HISTORIC AND DESIGN REVIEW COMMISSION

May 19, 2021

HDRC CASE NO: 2020-436
ADDRESS: 245 W WILDWOOD
LEGAL DESCRIPTION: NCB 9013 BLK 7 LOT 69 70 AND 71
ZONING: R-4, H
CITY COUNCIL DIST.: 1
DISTRICT: Olmos Park Terrace Historic District
APPLICANT: MCGOVERN TIMOTHY J & CHELSEA
OWNER: MCGOVERN TIMOTHY J & CHELSEA
TYPE OF WORK: Construction of a 1-story rear addition, fenestration modifications, exterior alterations
APPLICATION RECEIVED: May 07, 2021
60-DAY REVIEW: Not applicable due to City Council Emergency Orders
CASE MANAGER: Rachel Rettaliata
REQUEST:

The applicant is requesting conceptual approval to:

Proposed Design : Front Street View
SCALE: 3/16" = 1' (1:64)

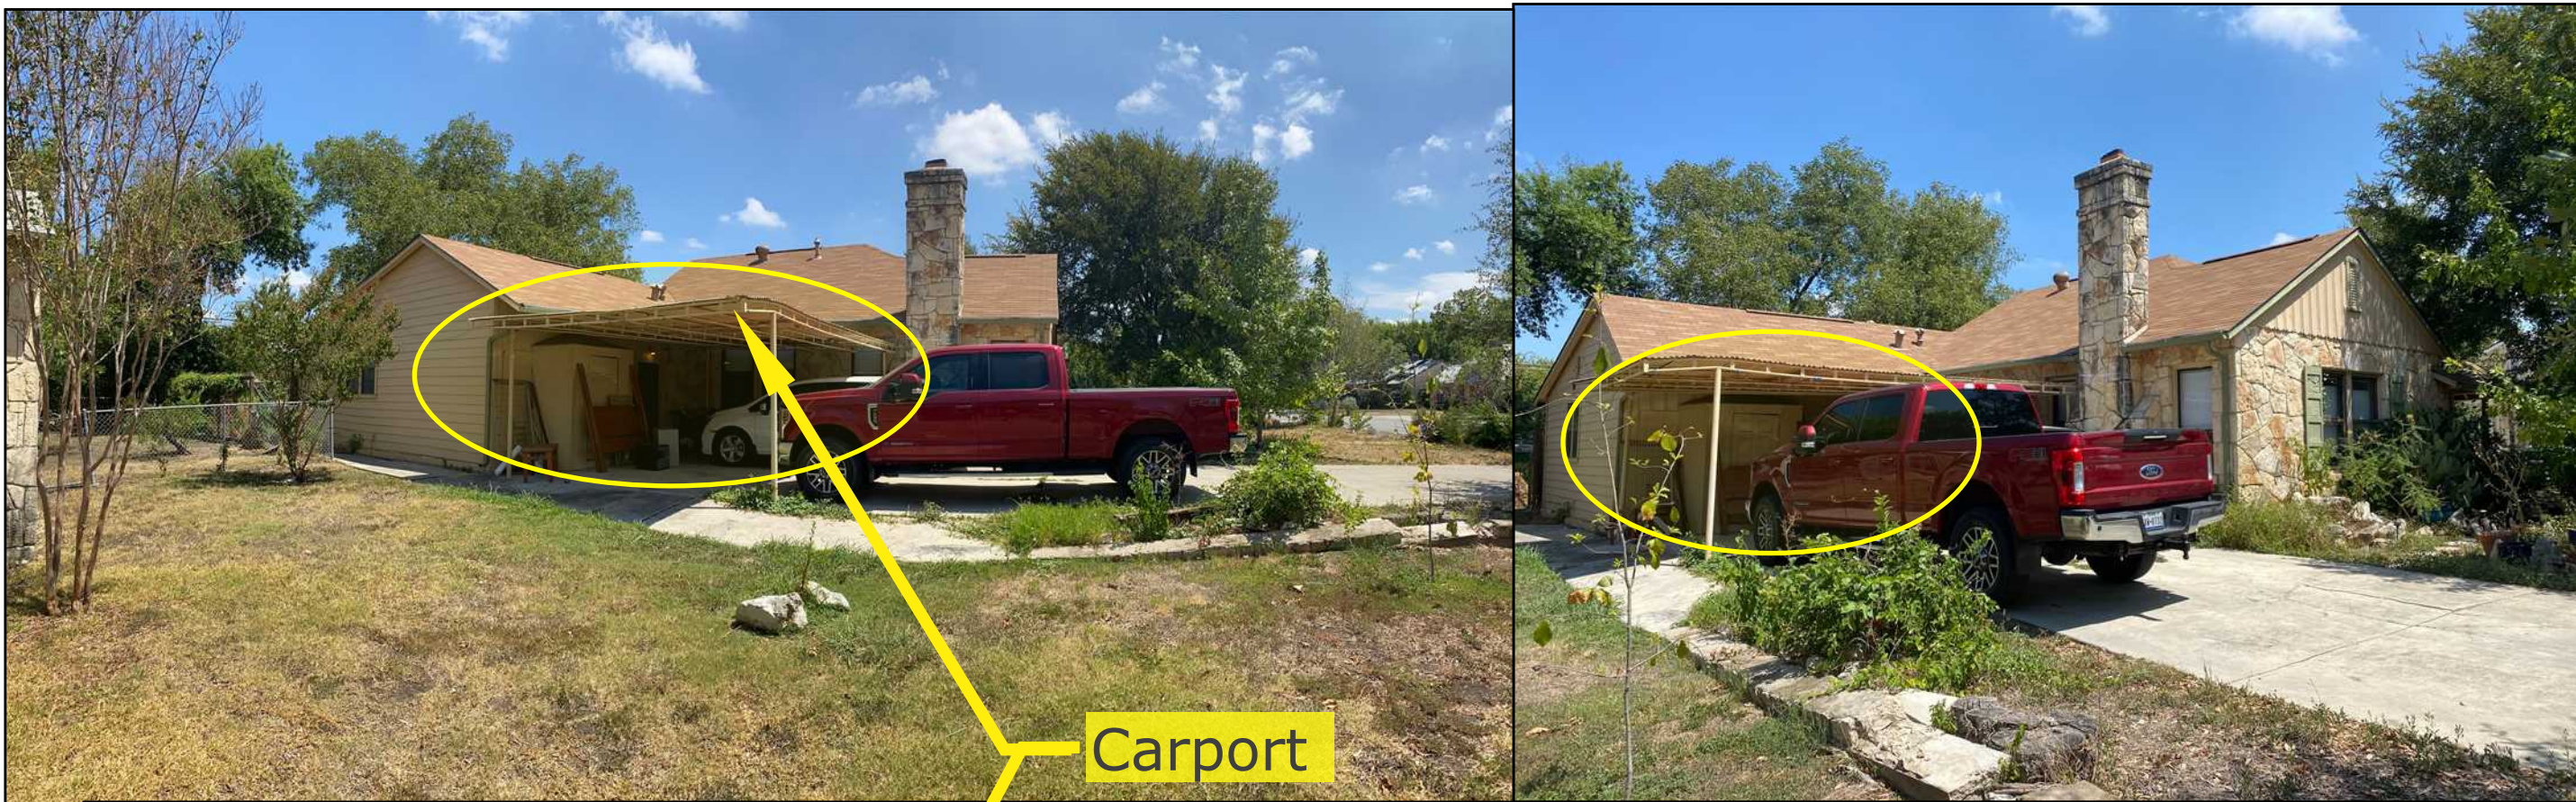
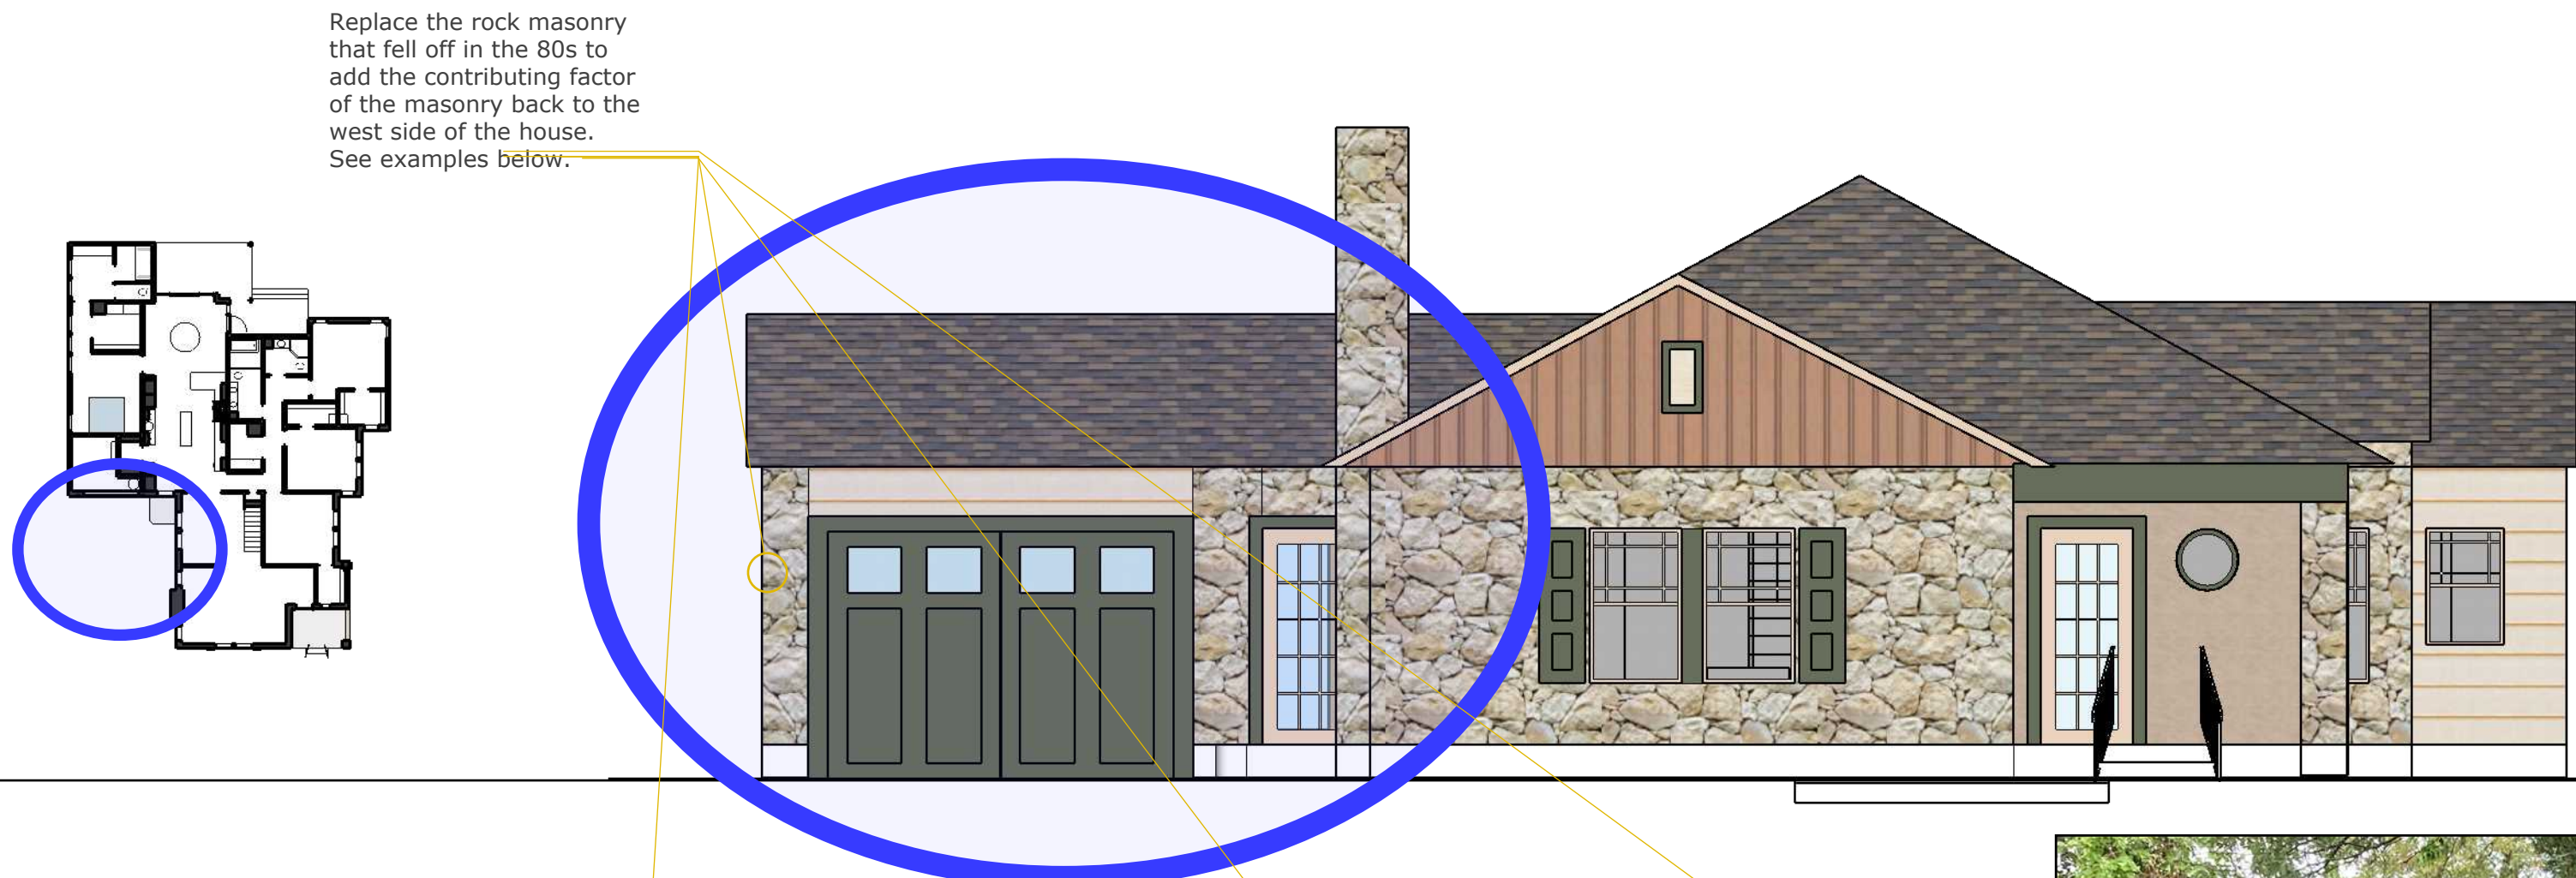
- o. **DRIVEWAY REPLACEMENT** – The applicant has requested to replace the fully concrete driveway with concrete pavers to increase water absorption on the property. Guideline 5.B.i for Site Elements states that historic driveway configurations should be retained and repaired. Incorporate a similar driveway configuration – materials, width, and design – to that historically found on the site. Historic driveways are typically no wider than 10 feet. Pervious paving surfaces may be considered where replacement is necessary to increase storm water infiltration. Staff finds the request for a permeable driveway surface appropriate but does not find the proposed paver material appropriate for a primary front driveway. Staff finds that a gravel driveway to be appropriate.

- i. That the applicant replaces the fully concrete driveway with a gravel driveway in the same footprint as existing. The applicant is required to submit material specifications for the gravel to staff for review and approval prior to the issuance of a Certificate of Appropriateness. The gravel should feature a natural color, shadow stone is not permitted.

Proposed Design : Front View
SCALE: 3/16" = 1' (1:64)

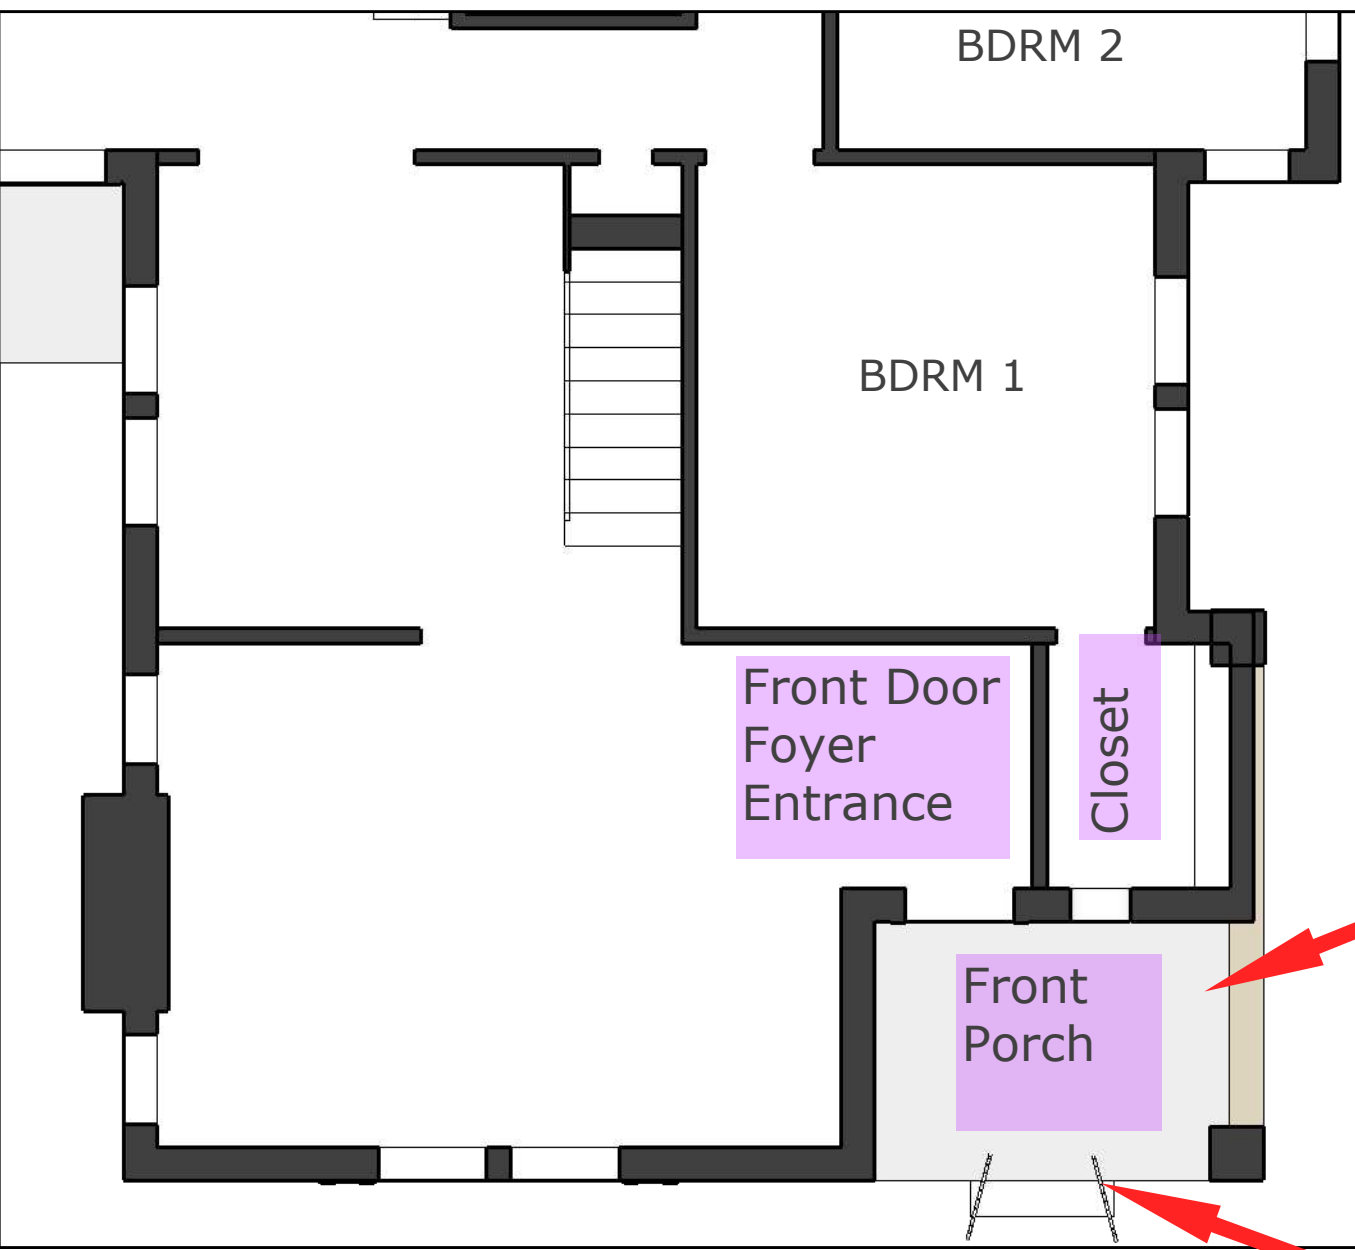
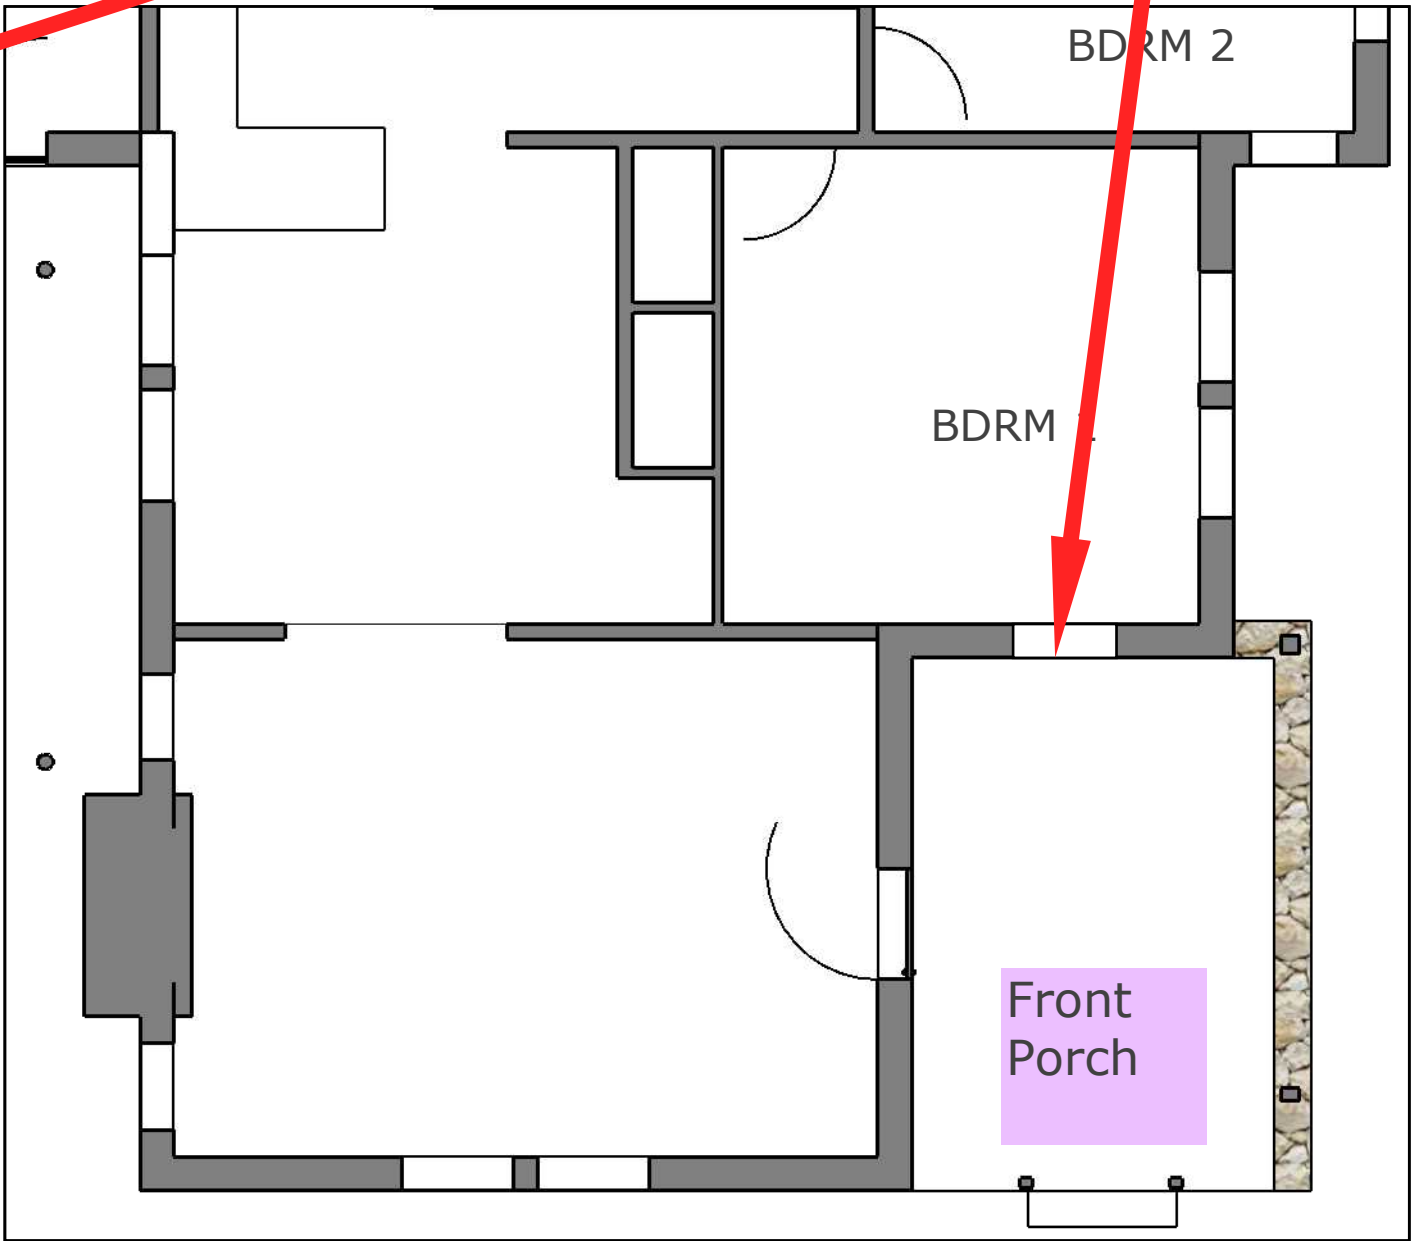
- l. **FRONT PORCH ENCLOSURE** – The applicant has proposed to enclose half of the existing front porch to use as interior living space to include a new front door location facing the street and a new window. According to the proposal, the modified front porch will be reduced to approximately 78 square feet. The existing front porch appears to be in the original footprint as seen in the 1933 Sanborn Map. Guideline 7.A.i for Exterior Maintenance and Alterations states that existing porches should be preserved. According to Guideline 7.B.i for Exterior Maintenance and Alterations, applicants should refrain from enclosing front porches. The applicant has provided precedent photos showing enclosed porches on other properties in the district. However, a majority of provided examples are secondary or side porches, versus the primary front porch of a home. Enclosures of side or secondary porches are not accurate precedent studies for the requested partial enclosure of 245 W Wildwood. Staff finds that the partial enclosure of the primary front porch of this home would significantly alter its original design. Staff finds the proposal inconsistent with the Guidelines.

- m. **FRONT PORCH: NEW FRONT DOOR INSTALLATION** – The applicant has proposed to move the front door opening from the east elevation of the front porch to face the street on the new front porch enclosure and enclose the existing front door opening with stucco cladding. The existing front door is not original. The front porch shows evidence of a previously existing opening centered on the exterior wall facing south. Guideline 6.A.i for Exterior Maintenance and Alterations stipulates that existing window and door openings should be preserved. Avoid enlarging or diminishing to fit stock sizes or air conditioning units. Avoid filling in historic door or window openings. Avoid creating new primary entrances or window openings on the primary façade or where visible from the public right-of-way. The applicant has provided evidence that the existing door opening is not original to the structure. Staff finds that installing a south-facing front door in the location of the previously existing opening is appropriate and that the existing east-facing front door opening should be retained.

- n. **FRONT PORCH: FENESTRATION MODIFICATION** – The applicant has proposed to install a circular window at the front porch to the east of the proposed relocated front door. The applicant has provided evidence that another front porch in the district features a circular window. Guideline 6.A.i for Exterior Maintenance and Alterations states that applicants should avoid creating new primary entrances or window openings on the primary façade or where visible from the public right-of-way. Staff finds the proposal inconsistent with the Guidelines.

Item 2, staff does not recommend approval of front porch enclosure based on finding 1. Staff finds that restoring the original front door opening would be an appropriate intervention.

- i. That the applicant installs a south facing front door centered on the exterior wall in the same location as the previously existing opening.
- ii. That the applicant retains the existing east-facing door opening.
- iii. That the proposed circular window is not installed on the new exterior wall.
- iv. That the applicant submits an updated elevation drawing for the front porch enclosure to staff for review and approval prior to the issuance of a Certificate of Appropriateness.
